FINAL REPORT

SNOWDRIFT ASSESSMENT PROPOSED WASTEWATER LAGOON CLYDE RIVER, NUNAVUT

Project Number: 08-1023

February 29, 2008

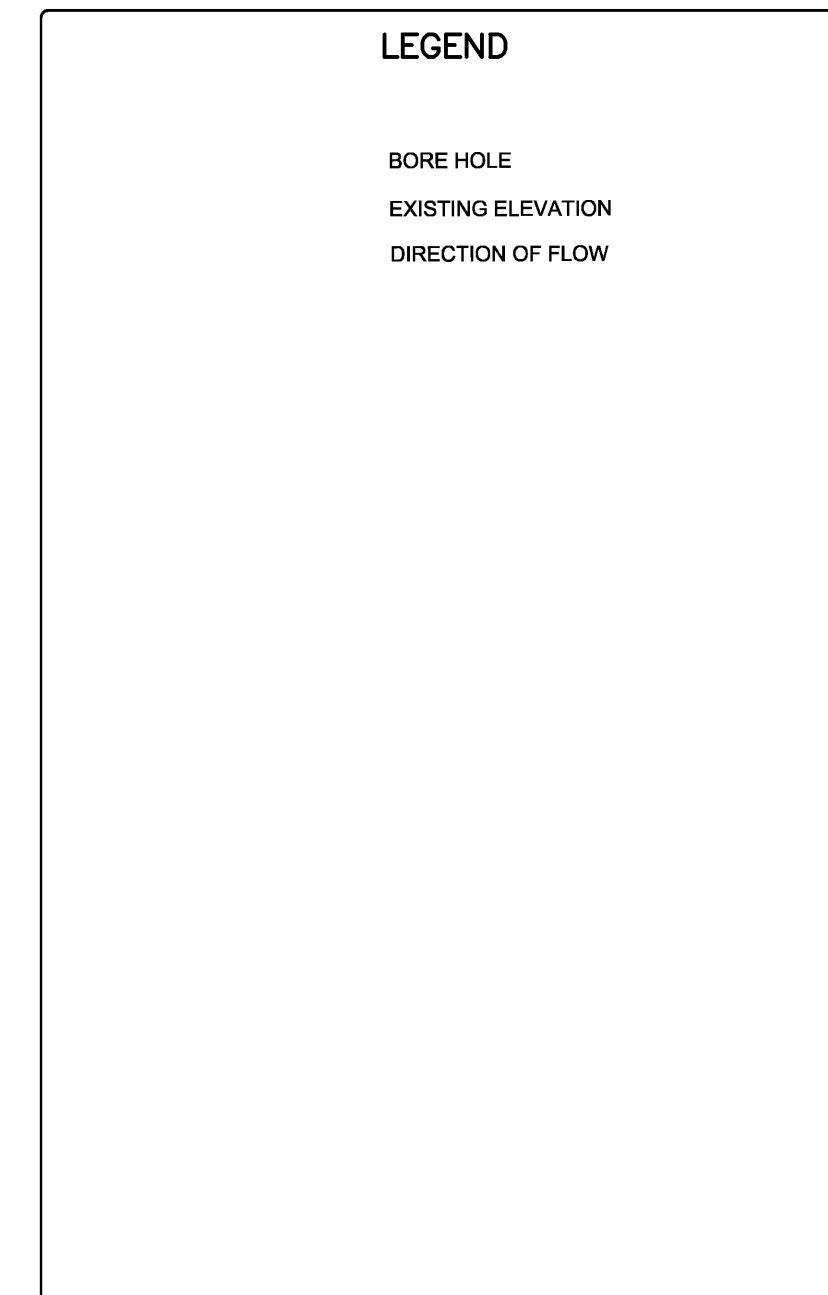
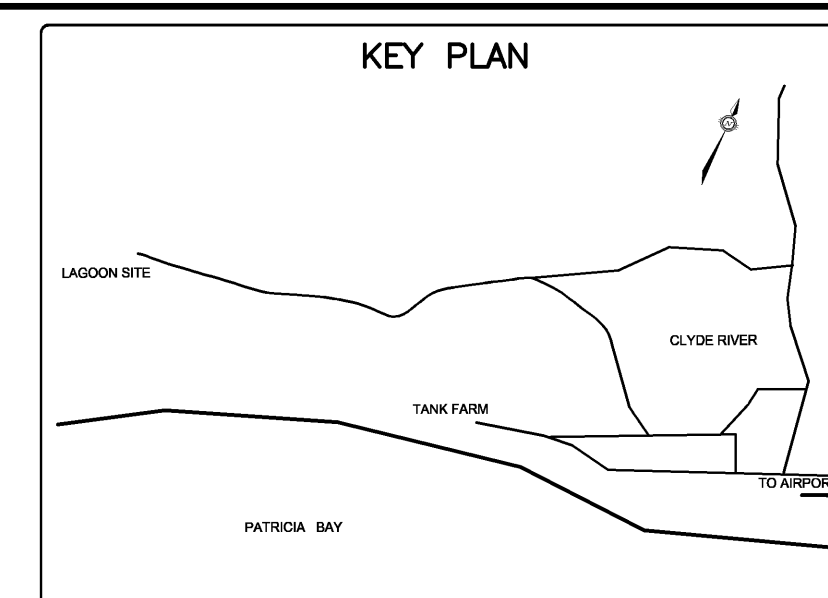
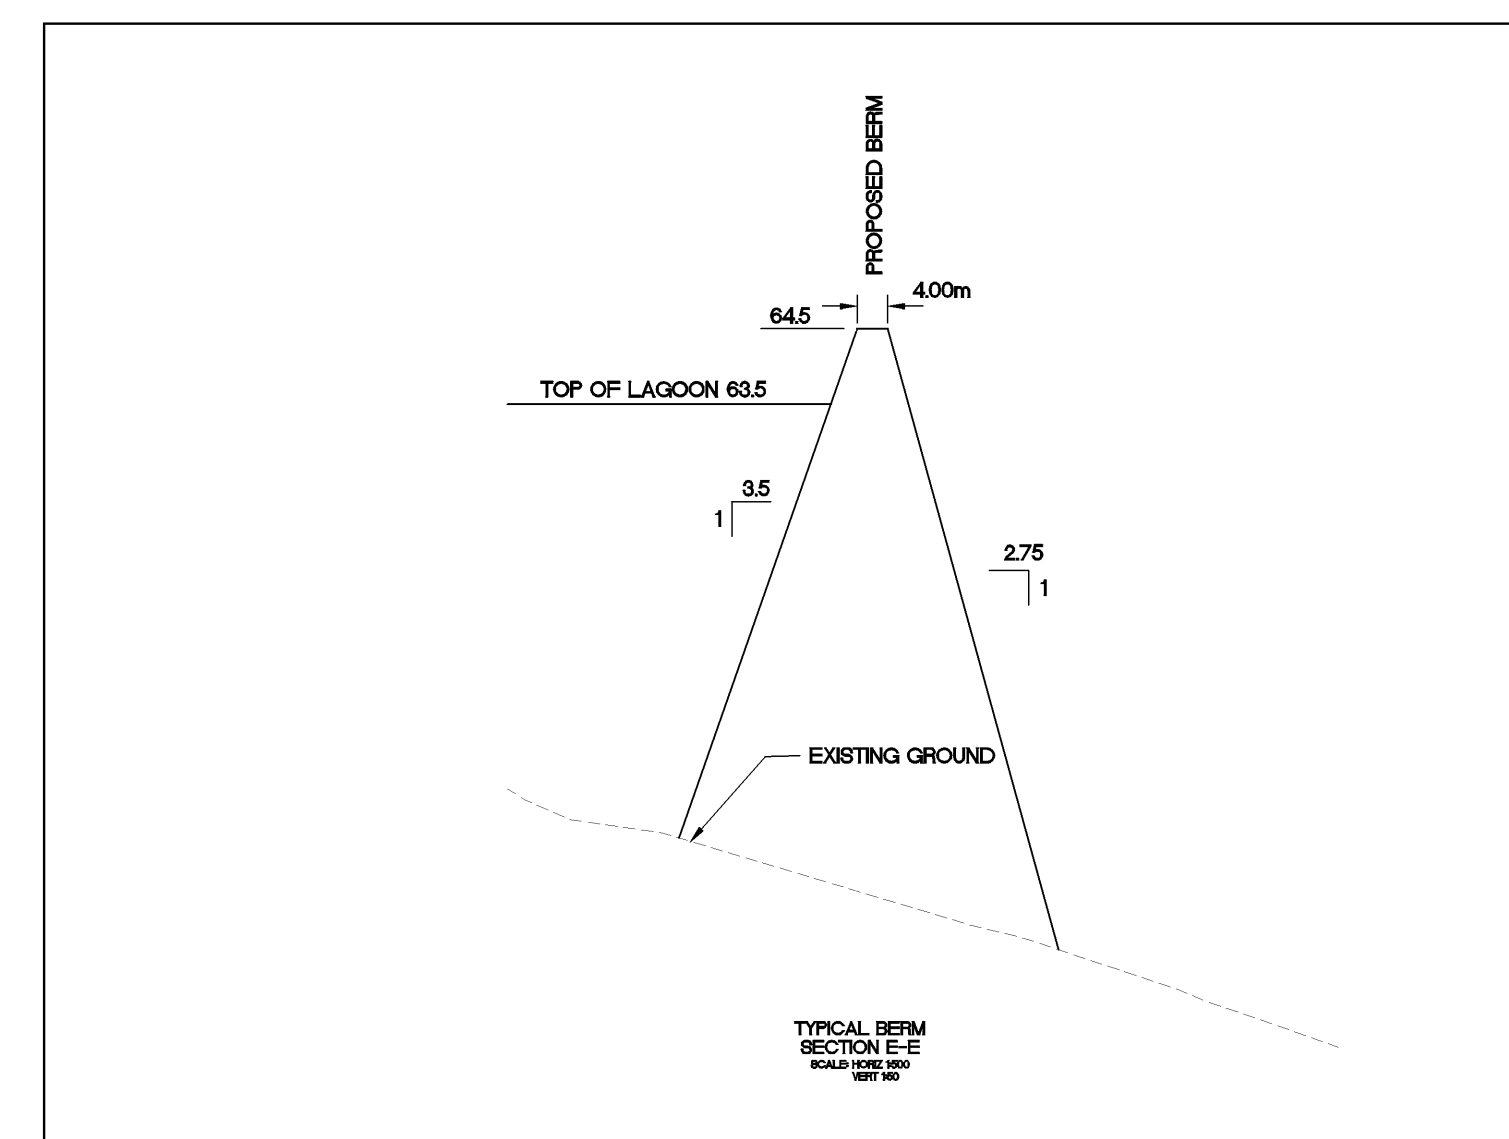
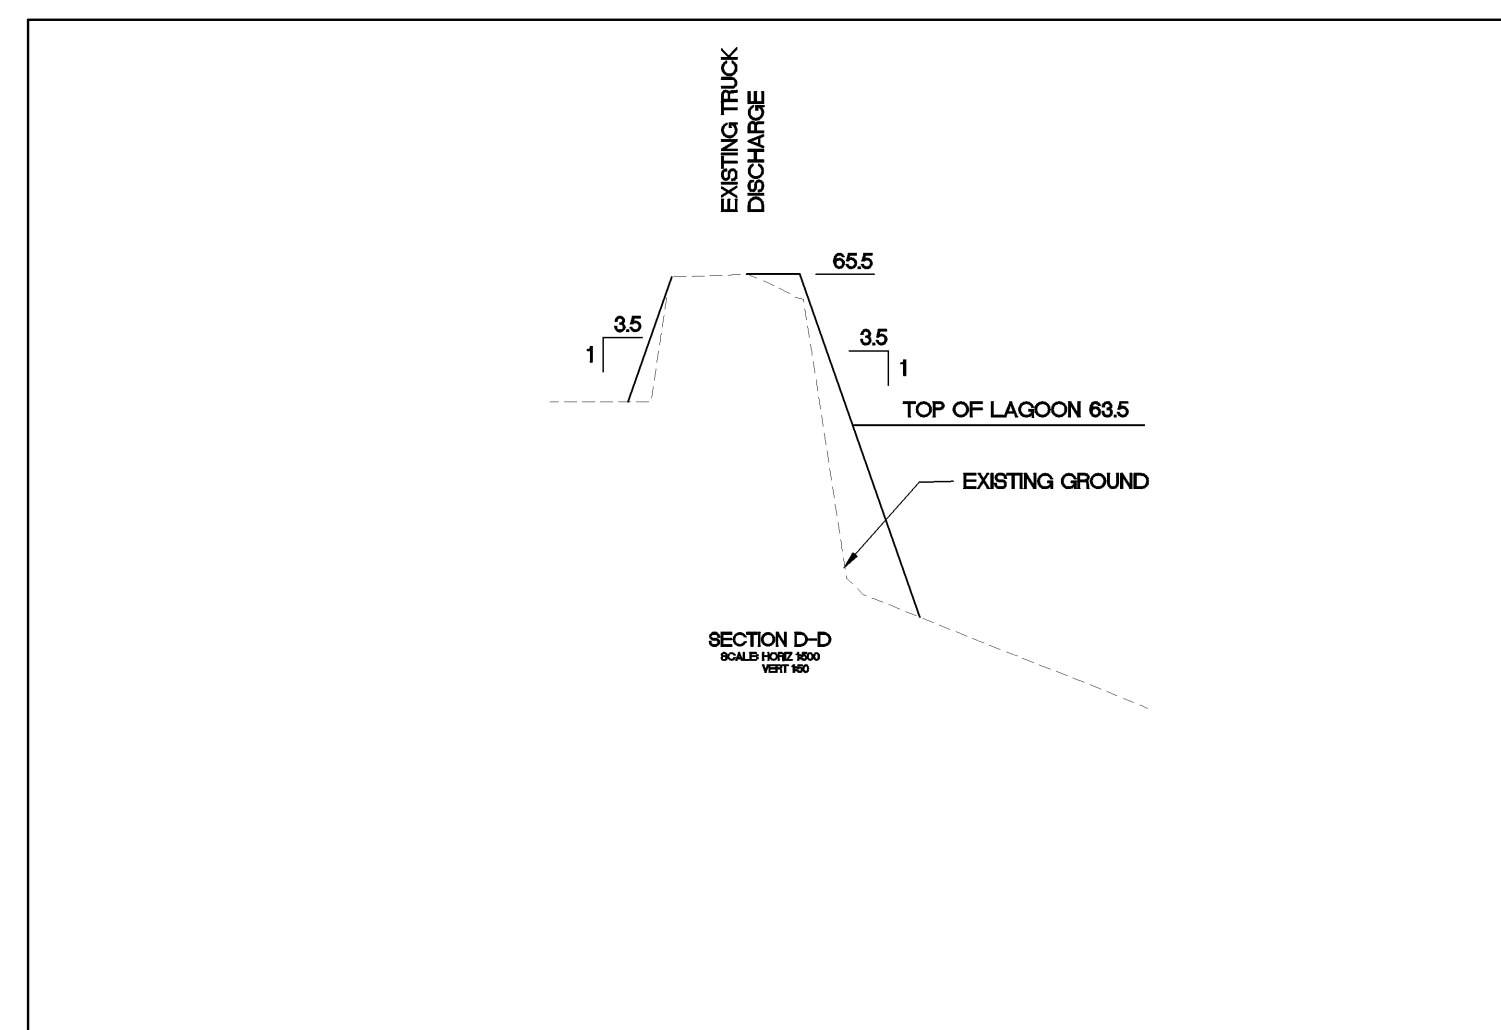
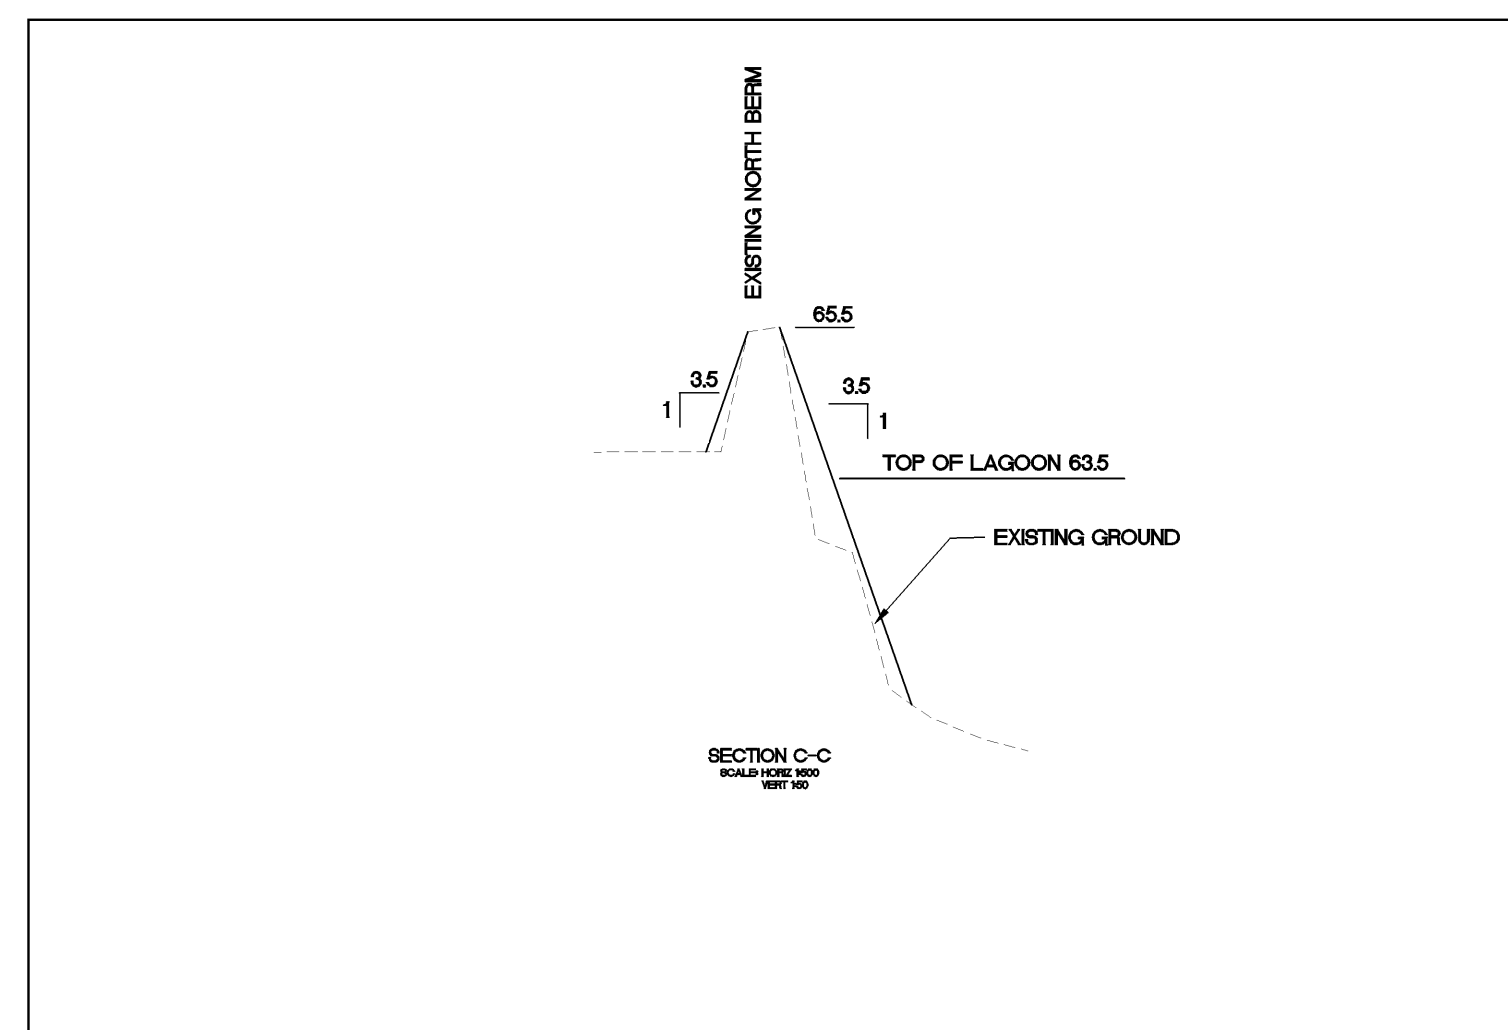
Assessment A (Refer to Appendix A) - The proposed wastewater lagoon is located adjacent to the existing lagoon west of the community. The sloped terrain in this area is not sufficient to create significant drifting problems. The site layout for the proposed lagoon shows a safety barrier along the edge of the existing lagoon as well as around the turn around and transfer area for the new lagoon. Large boulders will be used as safety barriers. Driver safety measures are essential, but it must be understood that the boulders will cause snowdrifts to form around them, and they will also impede snow removal operations. The Hamlet will use a front-end loader to remove snow from the lagoon area, as necessary. Snow should be dumped to the east side of the gravel pad to reduce the potential of the piled snow causing secondary drifting on top of the pad.
